325 - 327 Deansgate – Manchester

Section 73 | December 2025
10185-SHP-A-B5D8-RP-DAS-004 | P01

The following Addendum has been prepared in support of a Section 73 application for 325-327 Deansgate, Manchester.

3.1 - Amended Design - Ground Plan

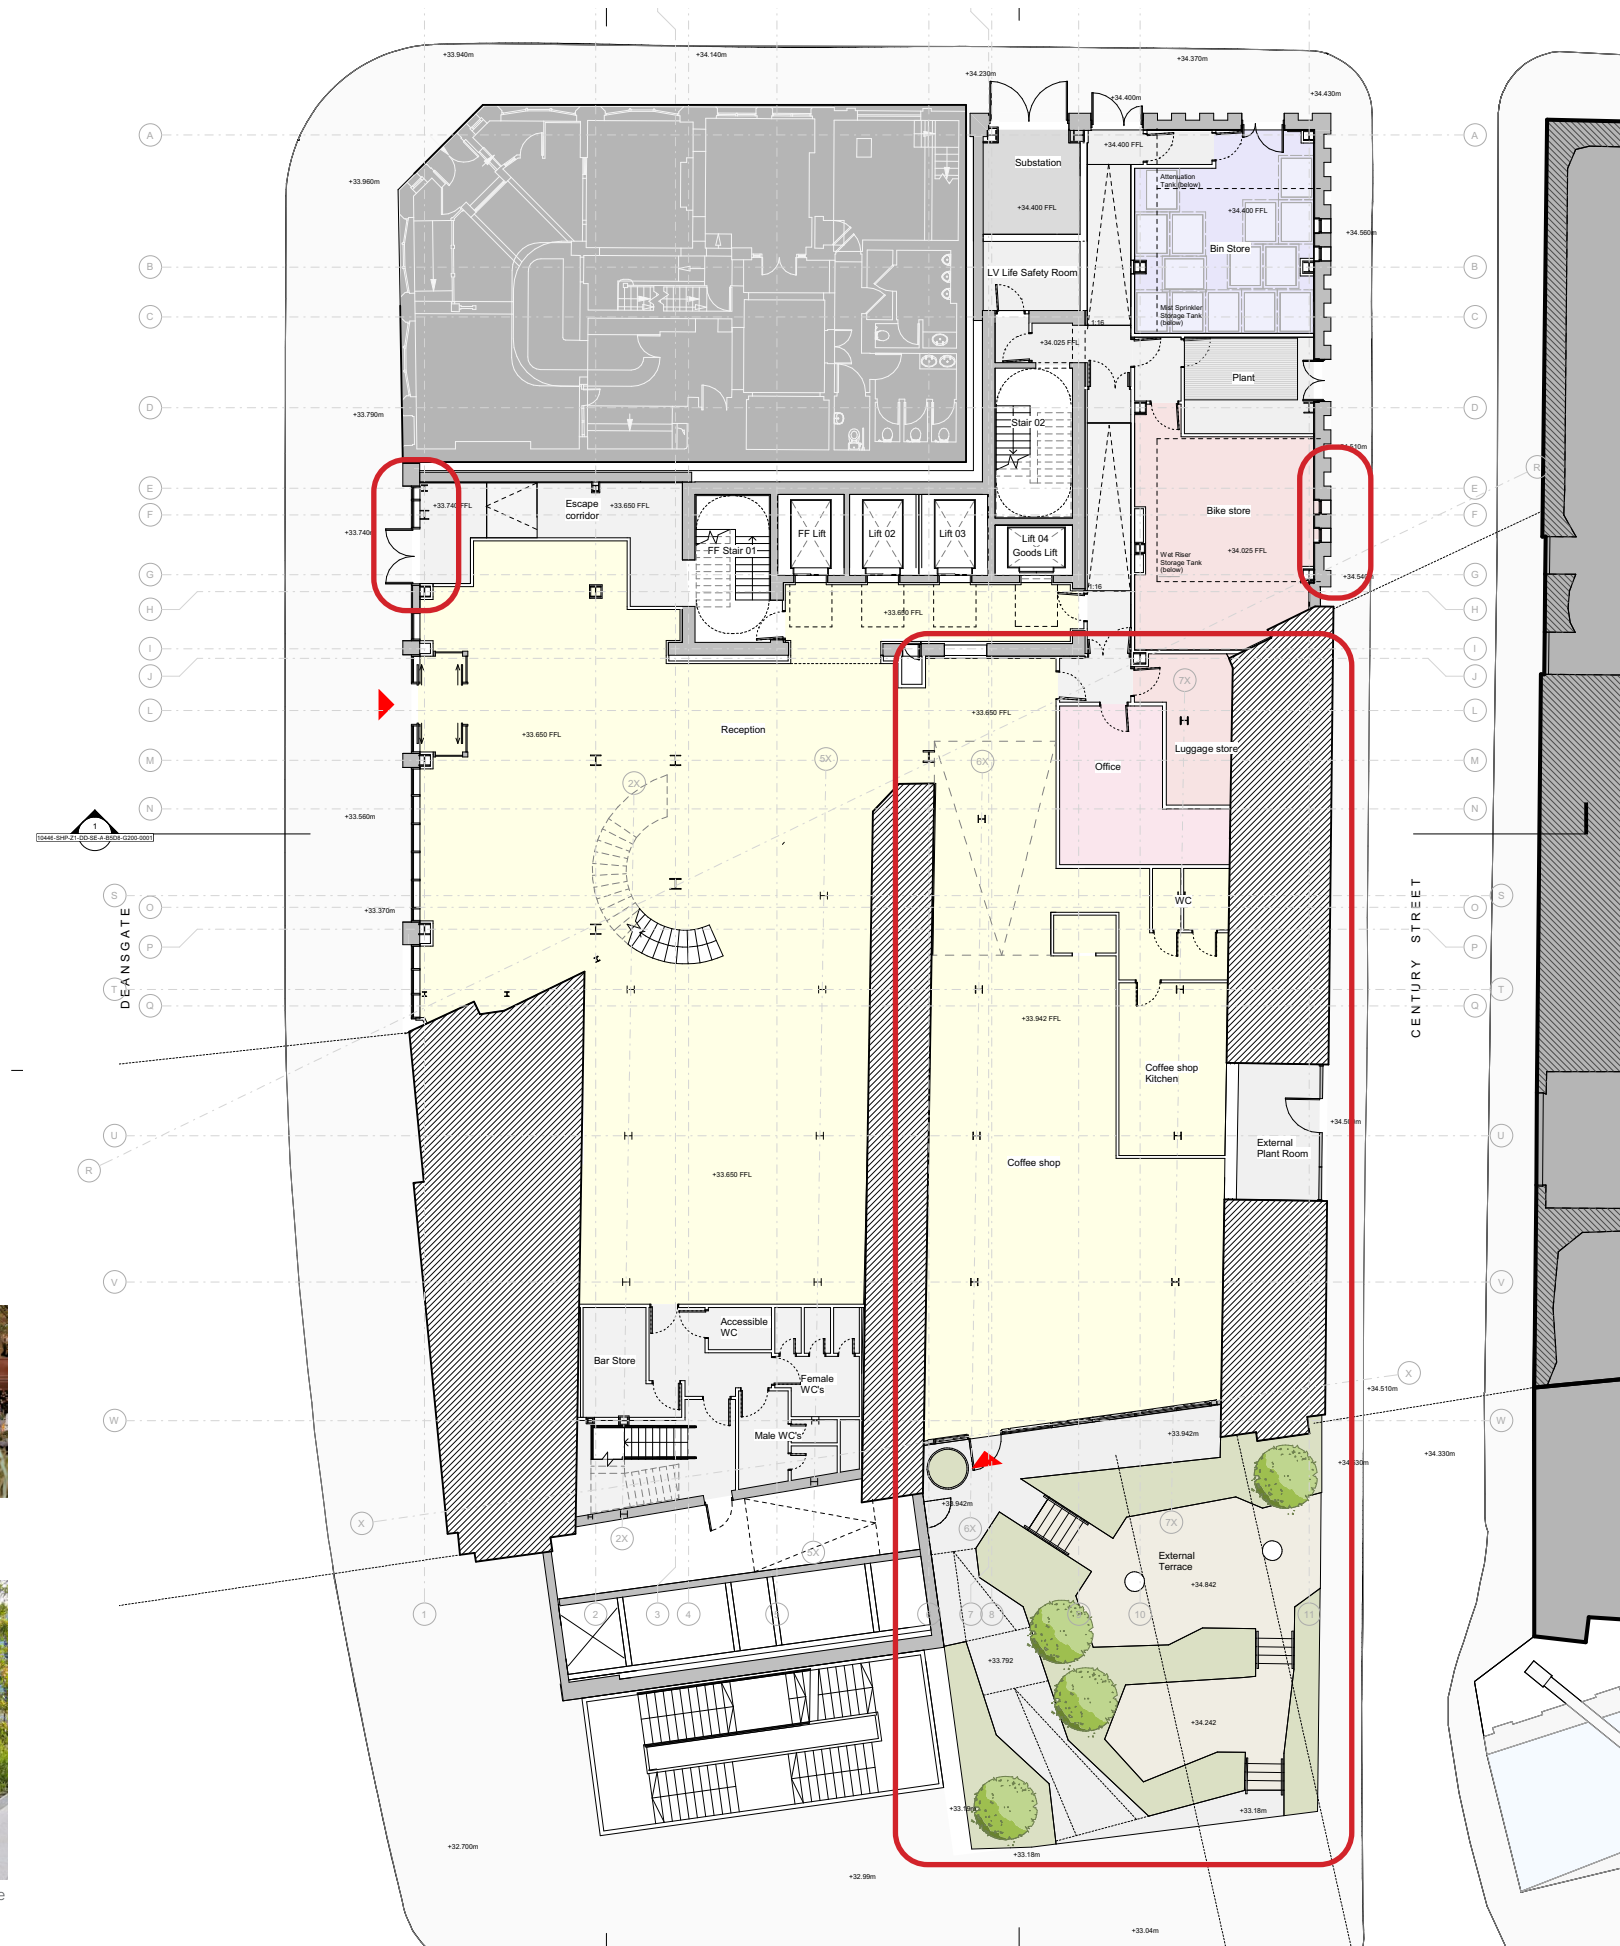
Amendments at Ground Floor

- Minor changes to layout including repositioning of the office and luggage store
- Commercial unit omitted. The coffee shop is incorporated into the Hotel reception
- Changes to fire escape glazing
- Removal of louvred door to linen store in place of 2no. louvres.
- Relocation of 4no. Trees

3.2 - Amended Design - Mezzanine

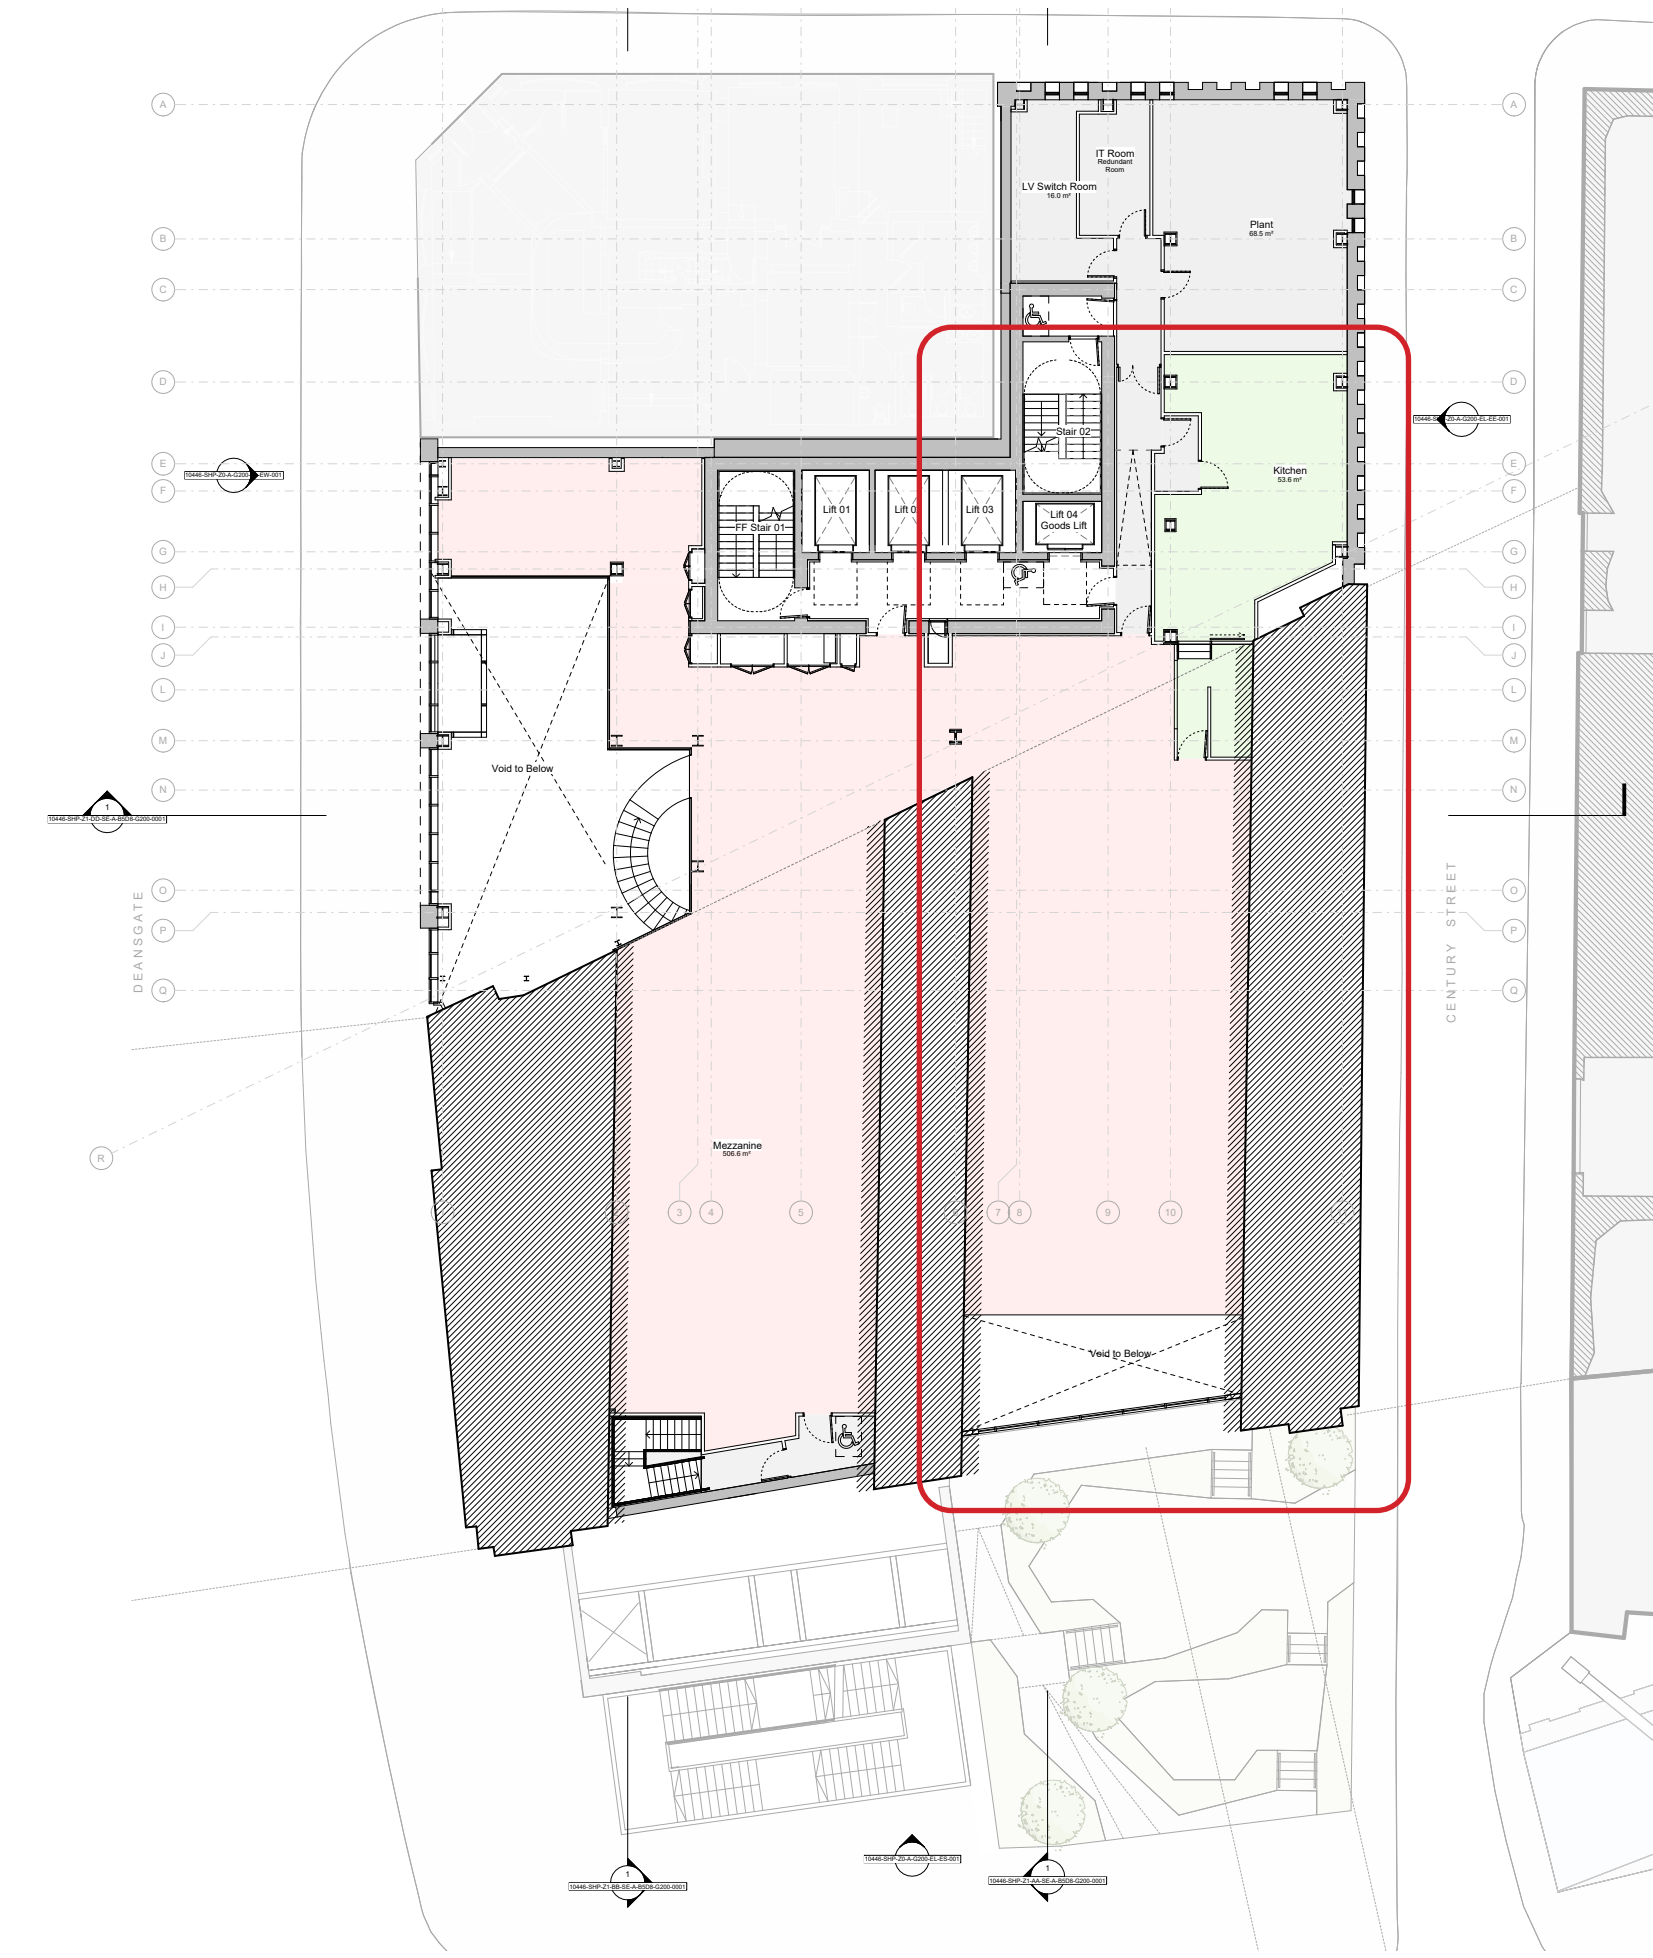
Amendments at Mezzanine Level

- Minor change to layout including relocated IT room, larger kitchen and relocation of the cycle store to ground floor
- Hotel mezzanine extended in 2nd arch

3.3 - Amended Design - First Floor Plan

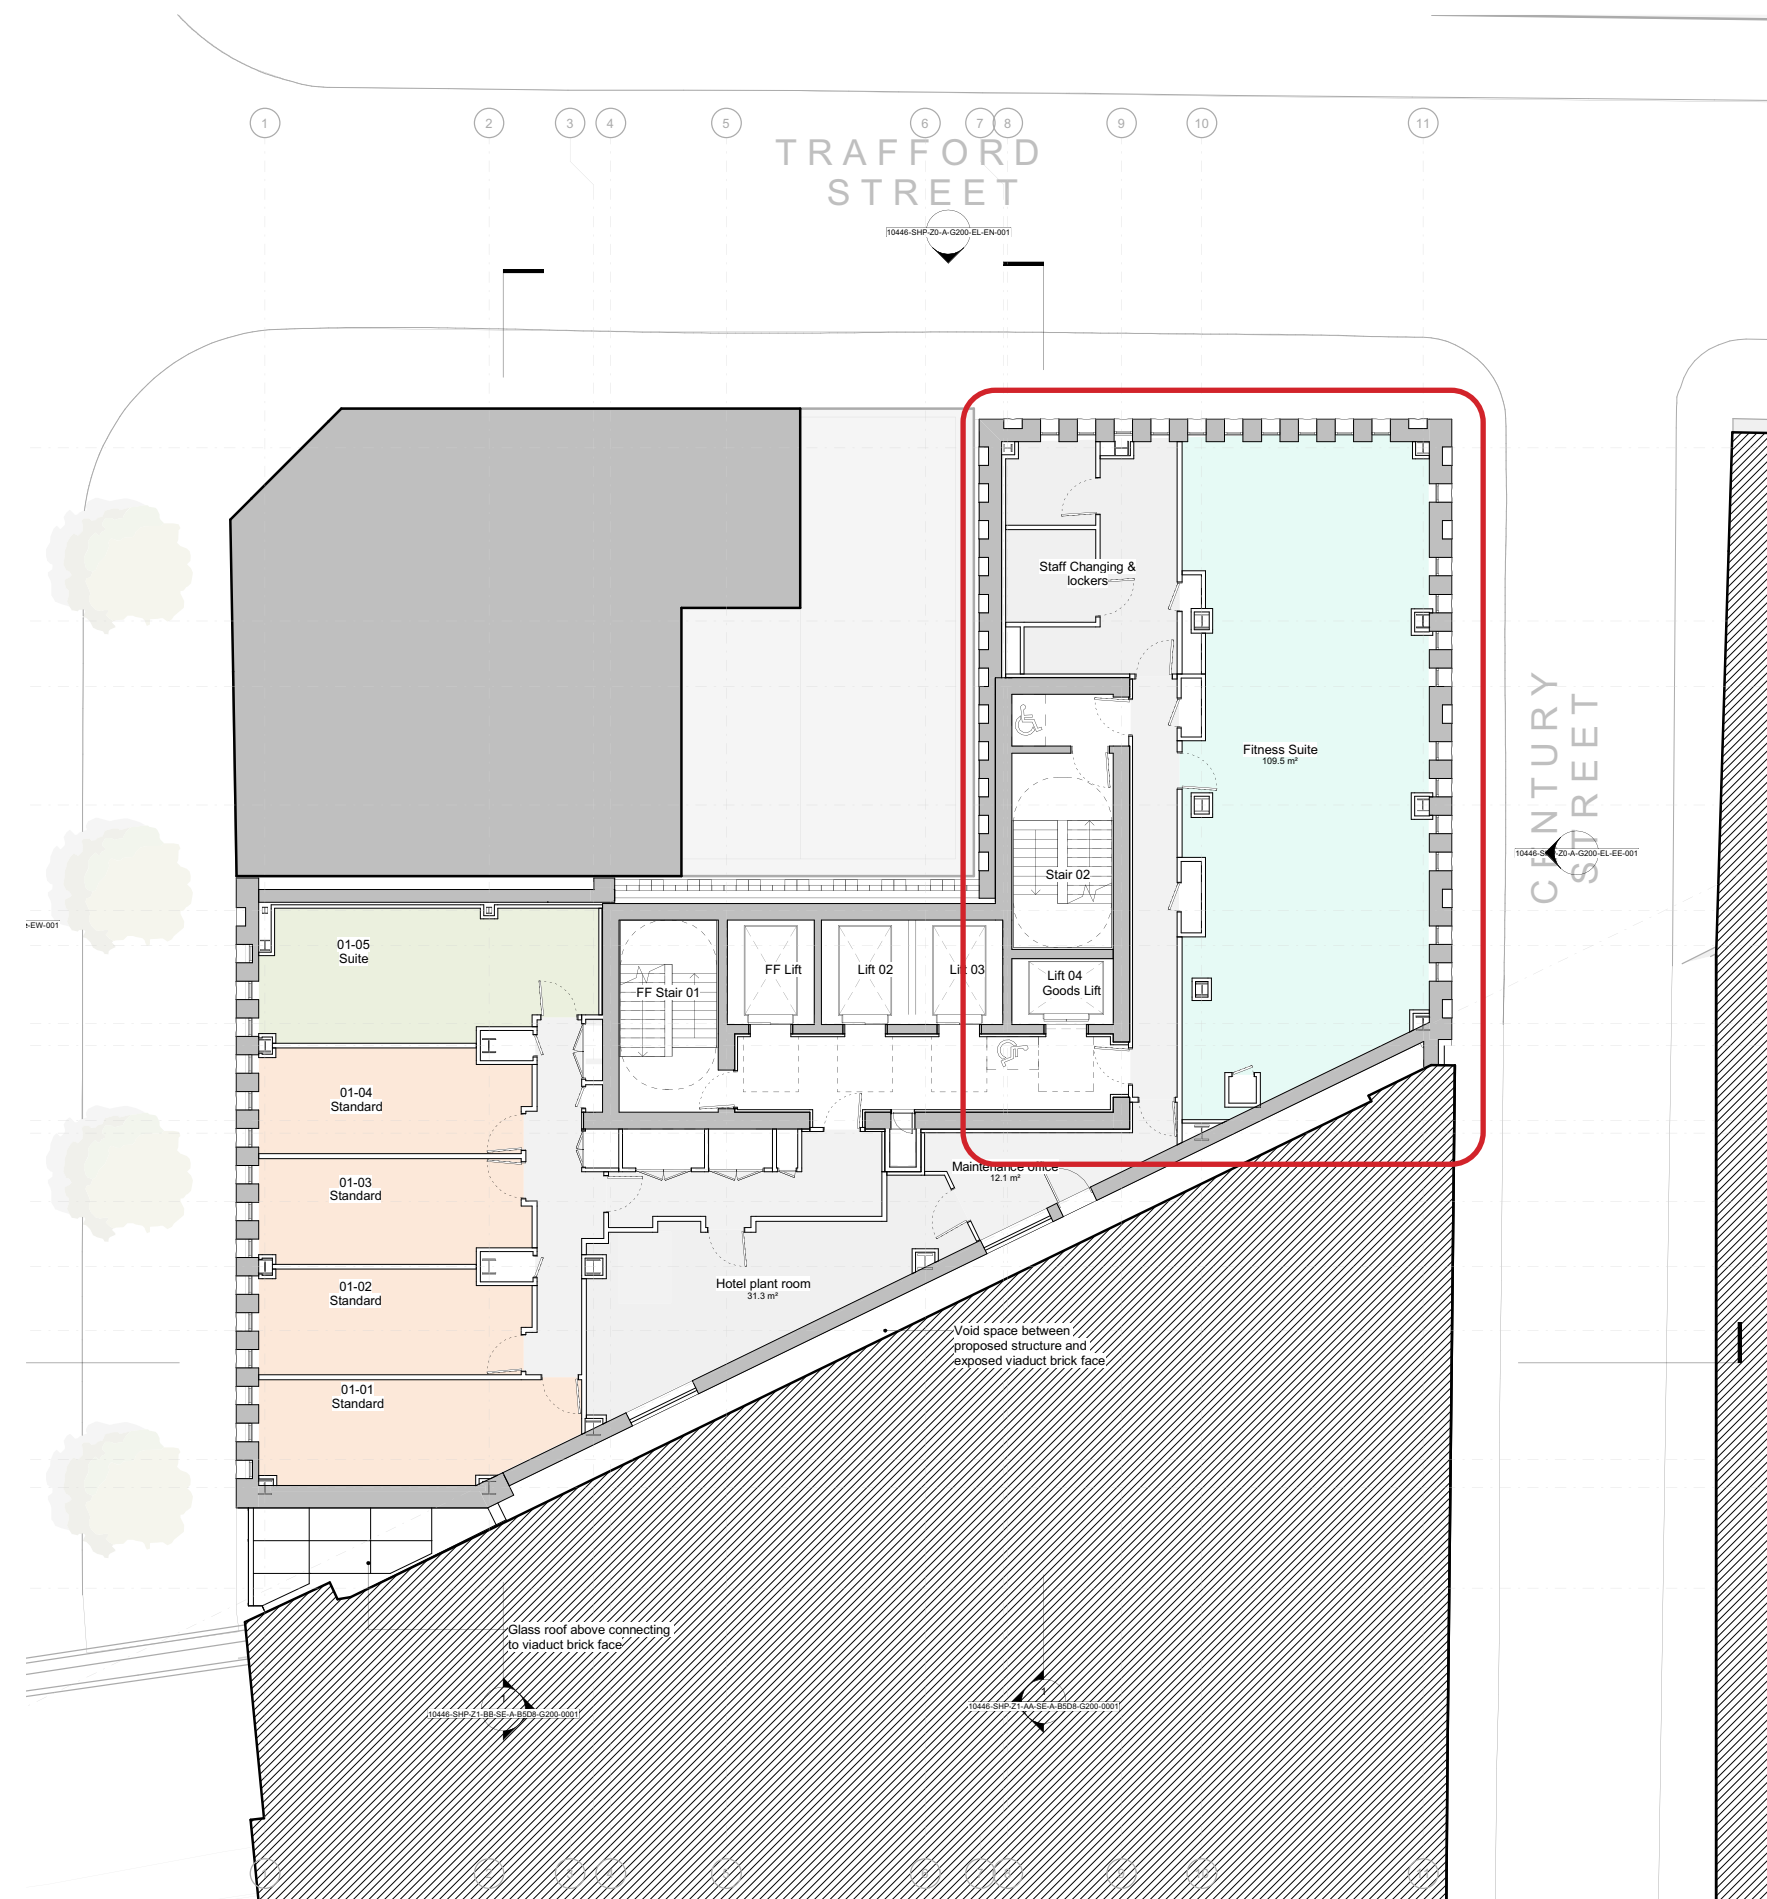
- Minor changes to space planning including staff changing facilities and gym moved to level 01
